ADDENDUM NO. 1

PROJECT NO.: MS-21-01

PROJECT: New Senior Center

SUBJECT: REVISED CIVIL DRAWINGS

C-101 – EXISTING CONDITIONS

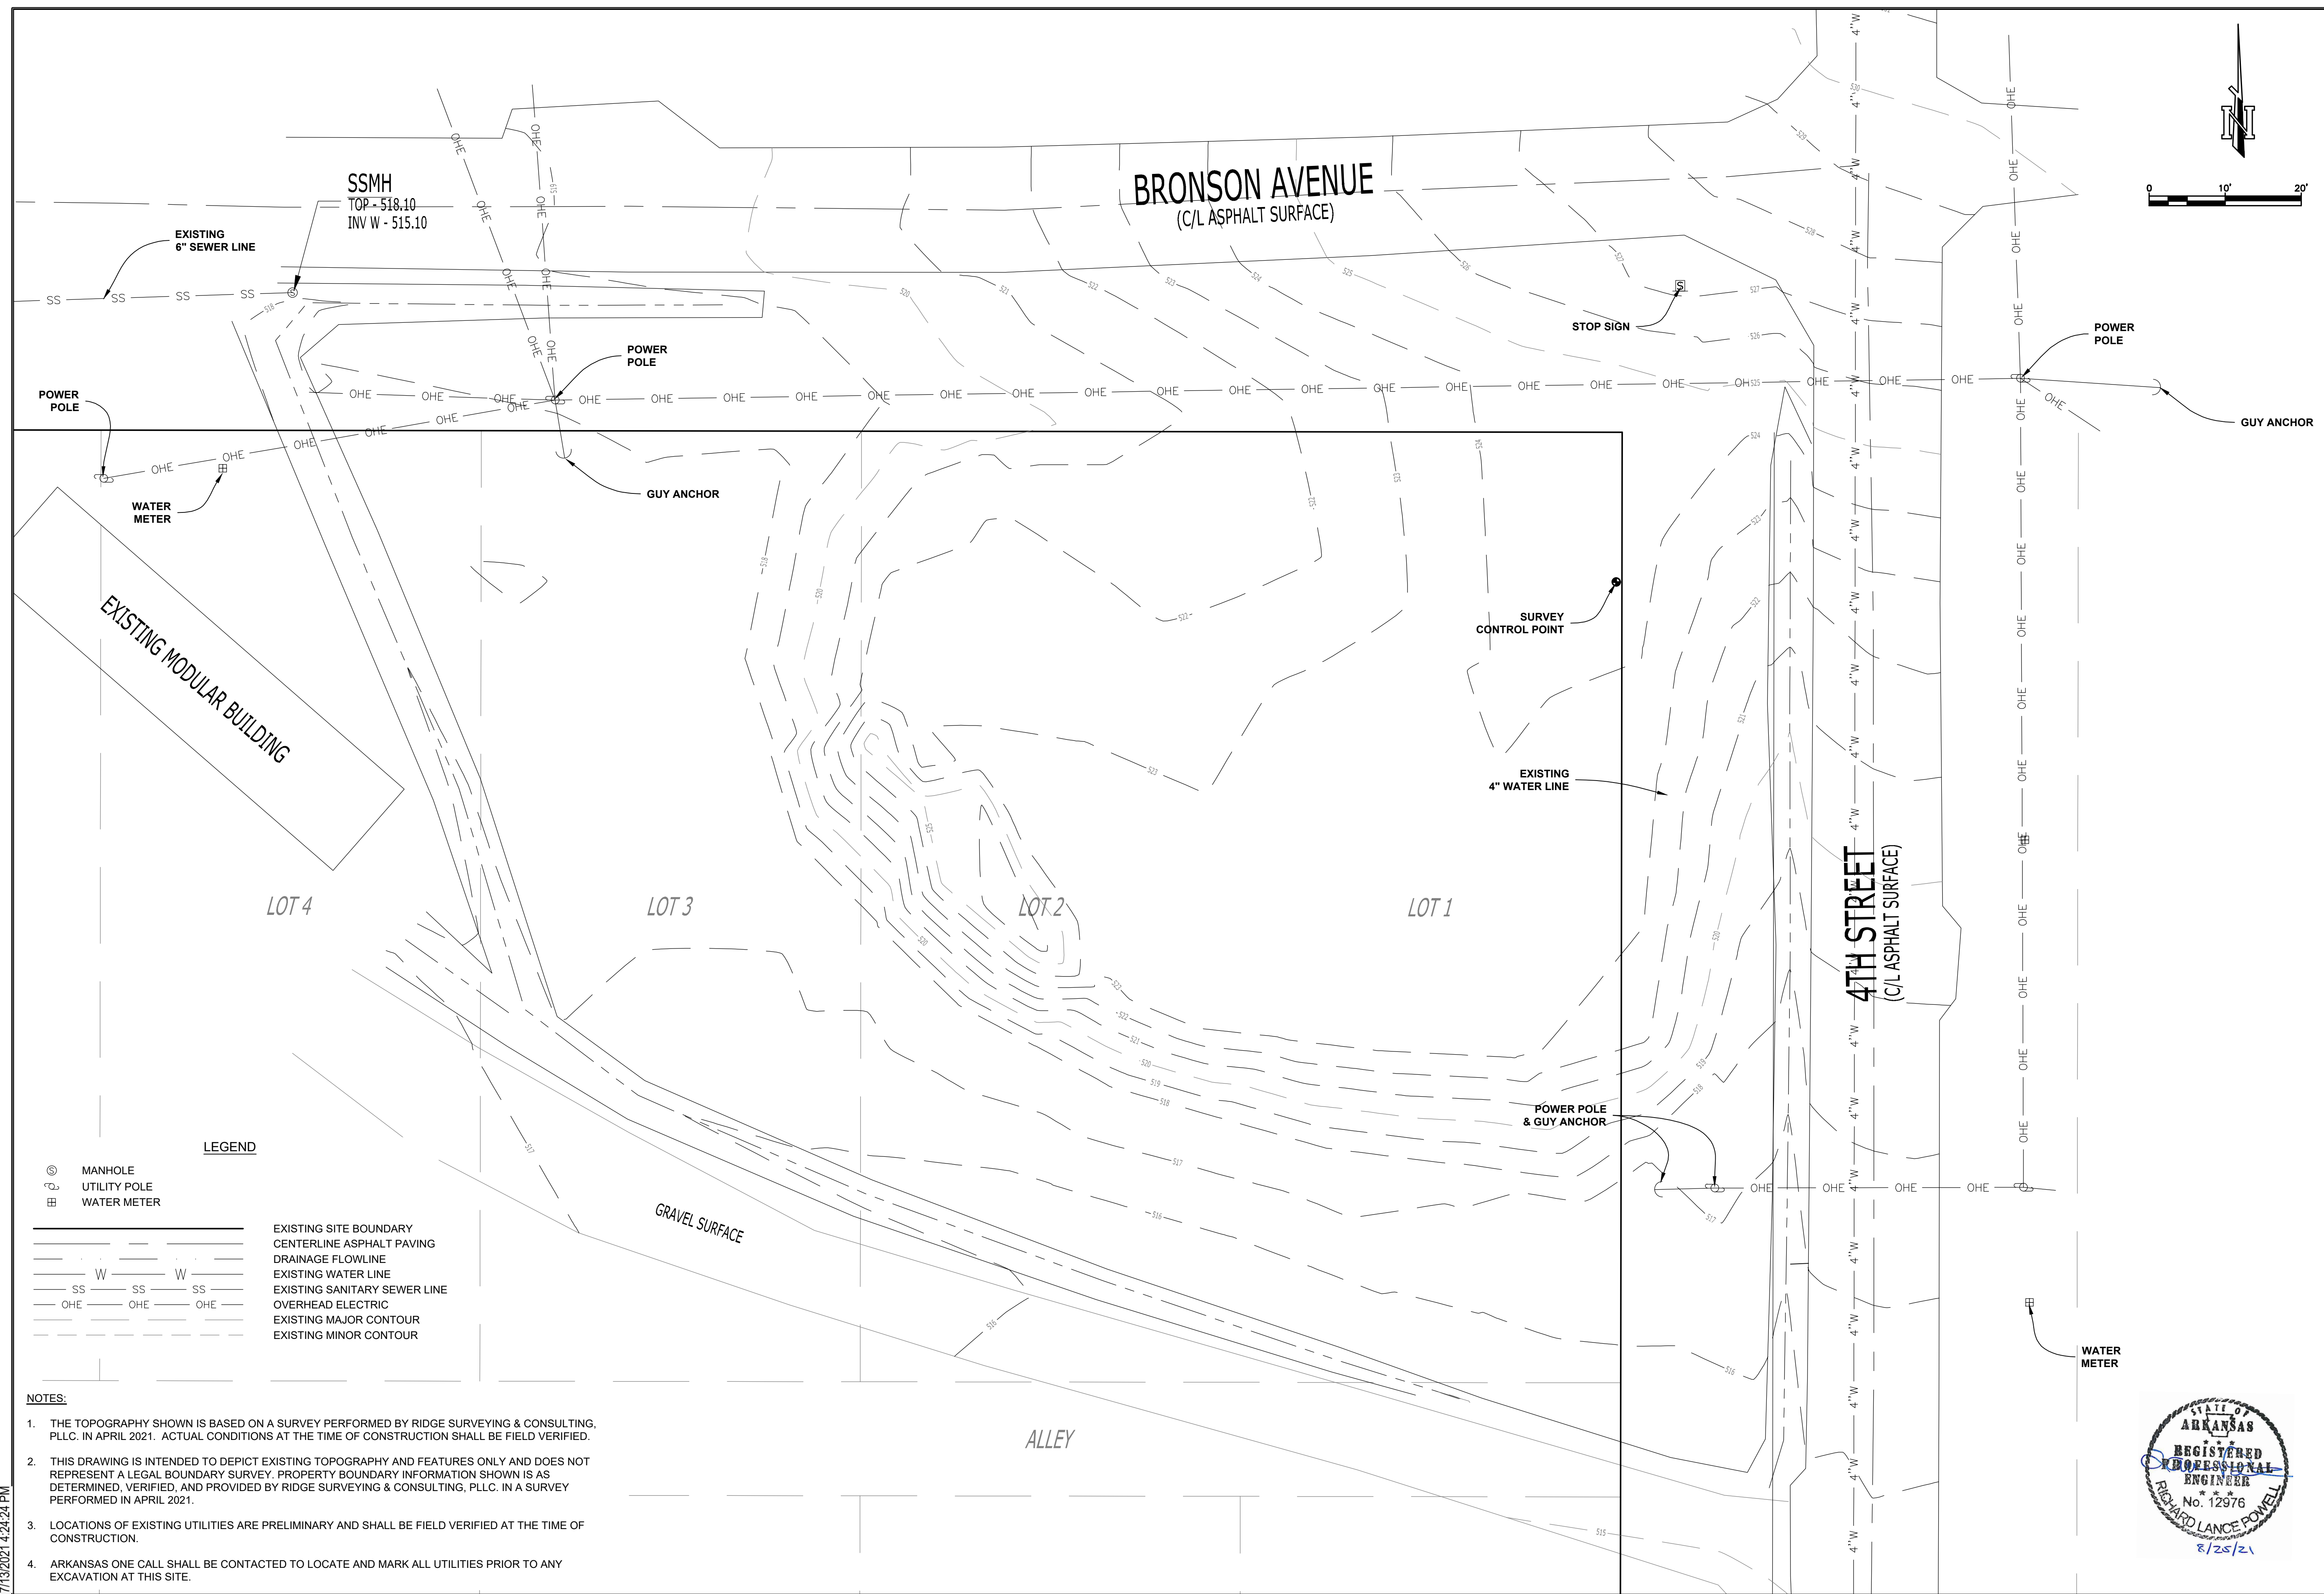
The Owner has been placing fill at the site, so the existing conditions drawing has been updated with a current topography survey.

C-103 – PROPOSED GRADING & UTILITY PLAN

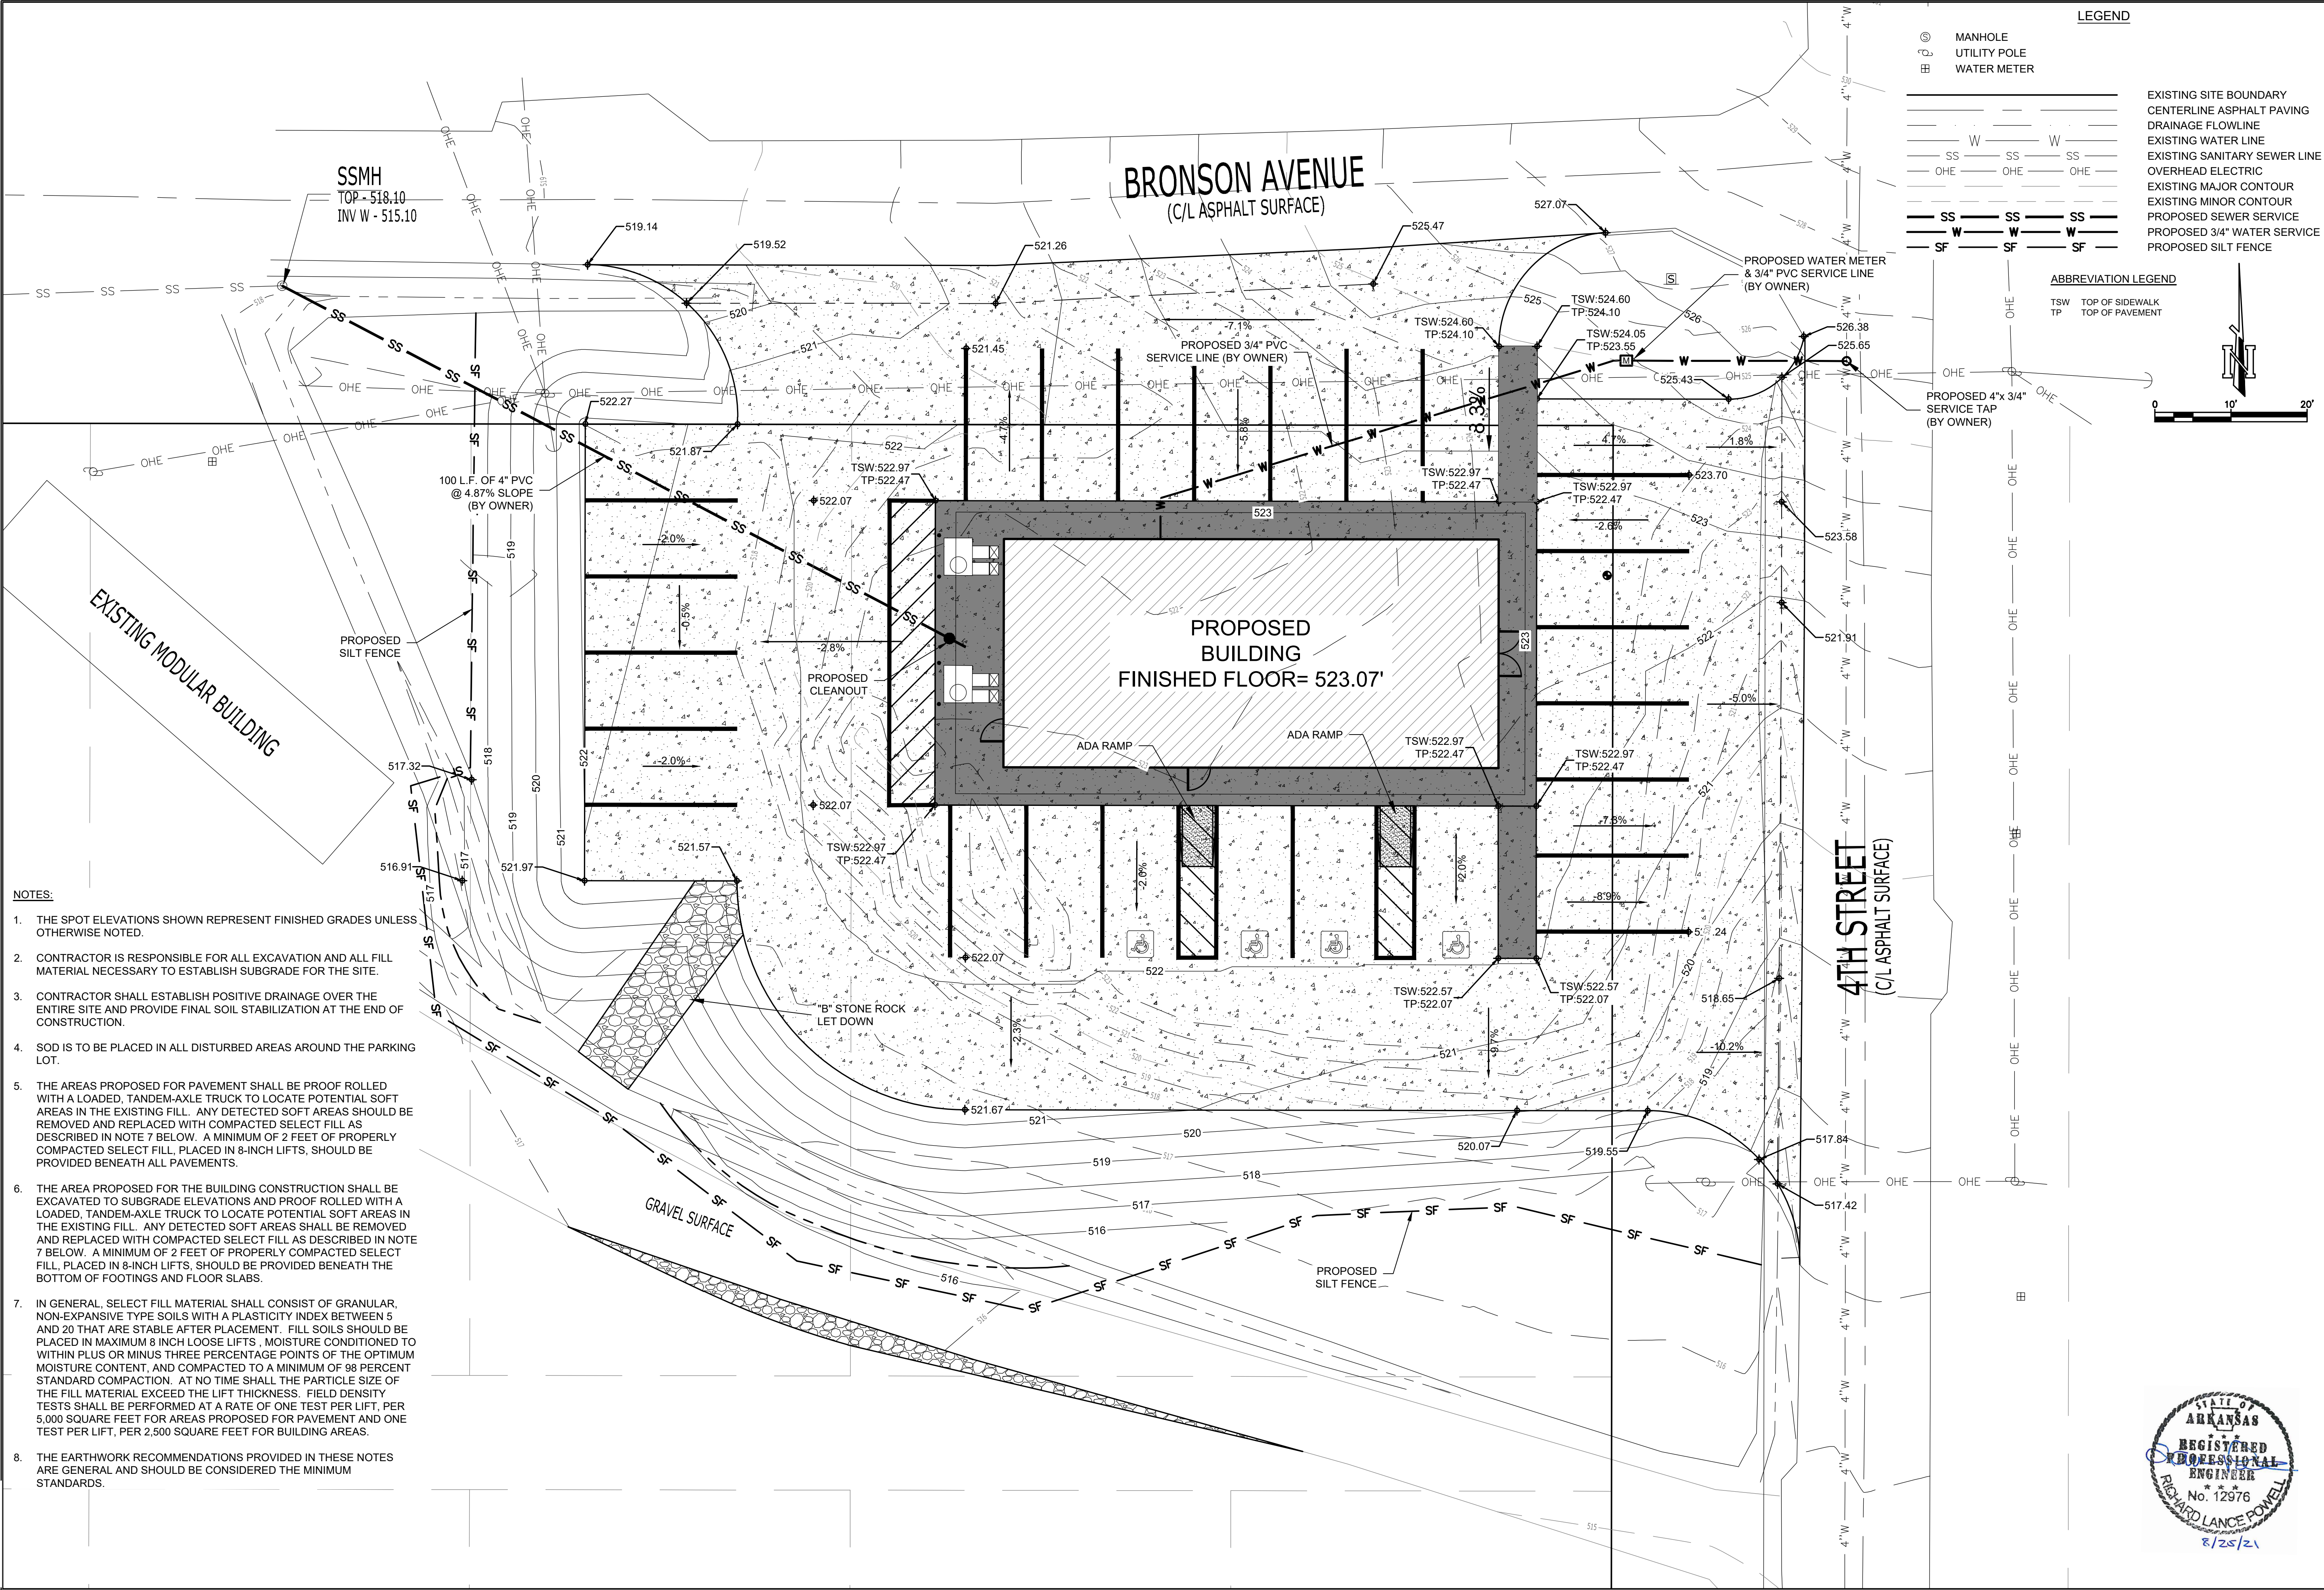
The notes referencing earthwork on the grading and utility plan drawing have been revised.

5. THE AREAS PROPOSED FOR PAVEMENT SHALL BE PROOF ROLLED WITH A LOADED, TANDEM-AXLE TRUCK TO LOCATE POTENTIAL SOFT AREAS IN THE EXISTING FILL. ANY DETECTED SOFT AREAS SHOULD BE REMOVED AND REPLACED WITH COMPACTED SELECT FILL AS DESCRIBED IN NOTE 7 BELOW. A MINIMUM OF 2 FEET OF PROPERLY COMPACTED SELECT FILL, PLACED IN 8-INCH LIFTS, SHOULD BE PROVIDED BENEATH ALL PAVEMENTS.

6. THE AREA PROPOSED FOR THE BUILDING CONSTRUCTION SHALL BE EXCAVATED TO SUBGRADE ELEVATIONS AND PROOF ROLLED WITH A LOADED, TANDEM-AXLE TRUCK TO LOCATE POTENTIAL SOFT AREAS IN THE EXISTING FILL. ANY DETECTED SOFT AREAS SHALL BE REMOVED AND REPLACED WITH COMPACTED SELECT FILL AS DESCRIBED IN NOTE 7 BELOW. A MINIMUM OF 2 FEET OF PROPERLY COMPACTED SELECT FILL, PLACED IN 8-INCH LIFTS, SHOULD BE PROVIDED BENEATH THE BOTTOM OF FOOTINGS AND FLOOR SLABS.

7. IN GENERAL, SELECT FILL MATERIAL SHALL CONSIST OF GRANULAR, NON-EXPANSIVE TYPE SOILS WITH A PLASTICITY INDEX BETWEEN 5 AND 20 THAT ARE STABLE AFTER PLACEMENT. FILL SOILS SHOULD BE PLACED IN MAXIMUM 8 INCH LOOSE LIFTS, MOISTURE CONDITIONED TO WITHIN PLUS OR MINUS THREE PERCENTAGE POINTS OF THE OPTIMUM MOISTURE CONTENT, AND COMPACTED TO A MINIMUM OF 98 PERCENT STANDARD COMPACTION. AT NO TIME SHALL THE PARTICLE SIZE OF THE FILL MATERIAL EXCEED THE LIFT THICKNESS. FIELD DENSITY TESTS SHALL BE PERFORMED AT A RATE OF ONE TEST PER LIFT, PER 5,000 SQUARE FEET FOR AREAS PROPOSED FOR PAVEMENT AND ONE TEST PER LIFT, PER 2,500 SQUARE FEET FOR BUILDING AREAS.
